Product Change Notification

Product Group: Vishay Tantalum capacitors / December 16, 2019 / PCN-TC-006-2019 Rev 0

Change of anode terminal design and unification of A-case Cu lead frame

T55 (A&B case) PREVIOUS TERMINAL DESIGN (Anode terminal)

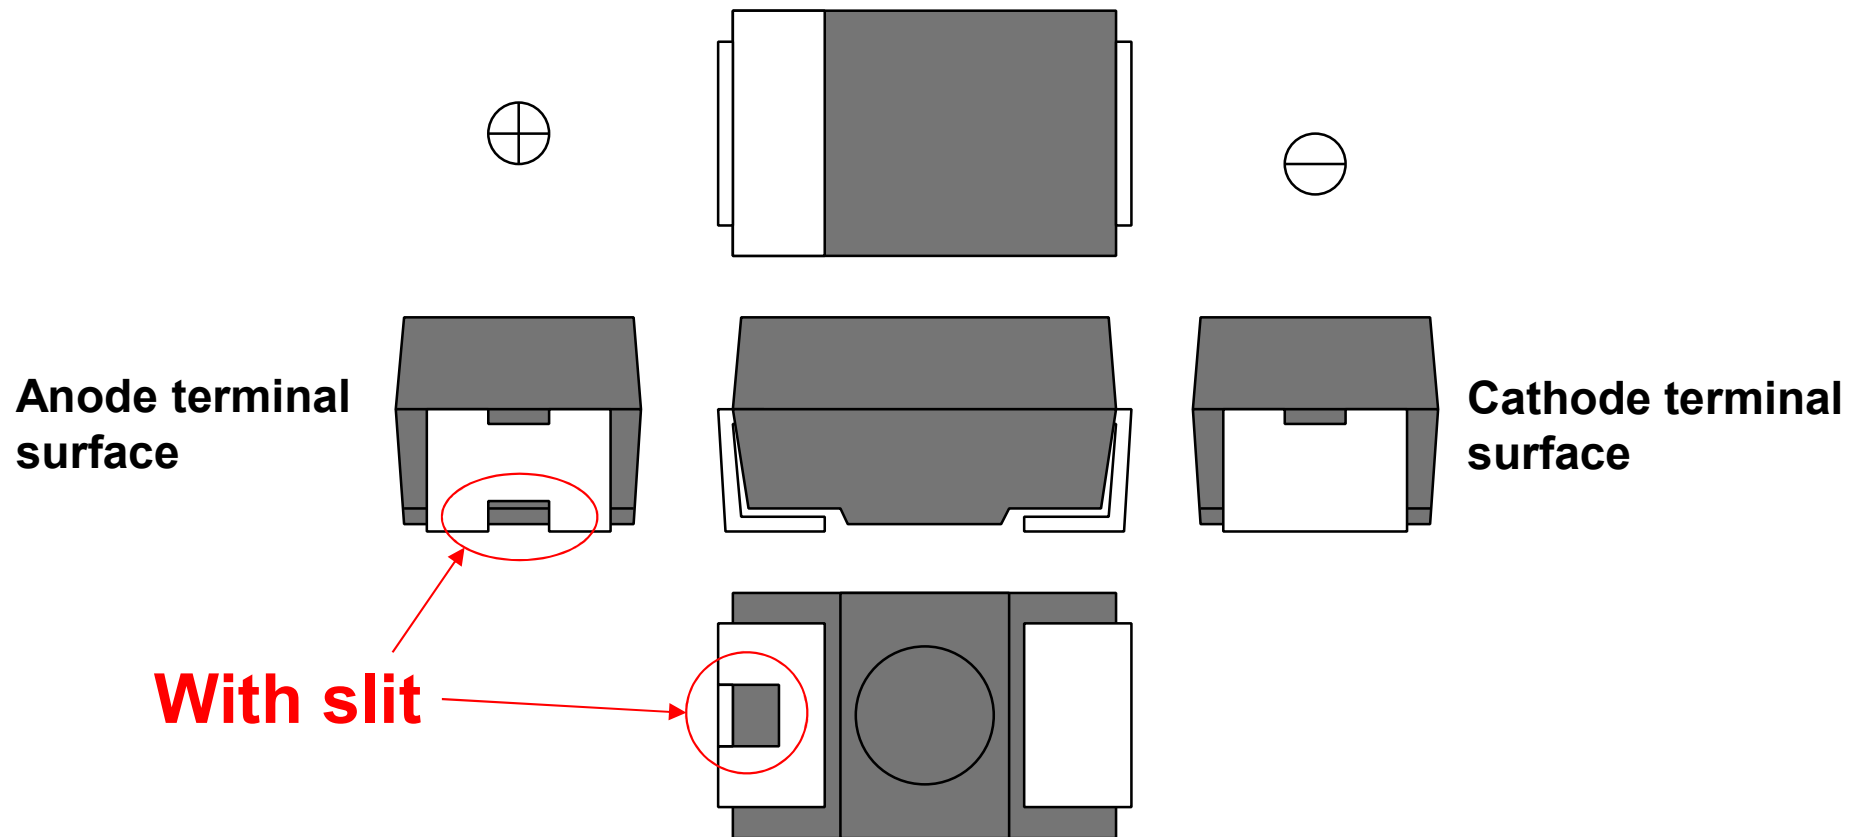
DESCRIPTION OF CHANGE: Minor terminal design change

REASON FOR CHANGE: Simplification of process by unifying slitless and A-case Cu lead frames
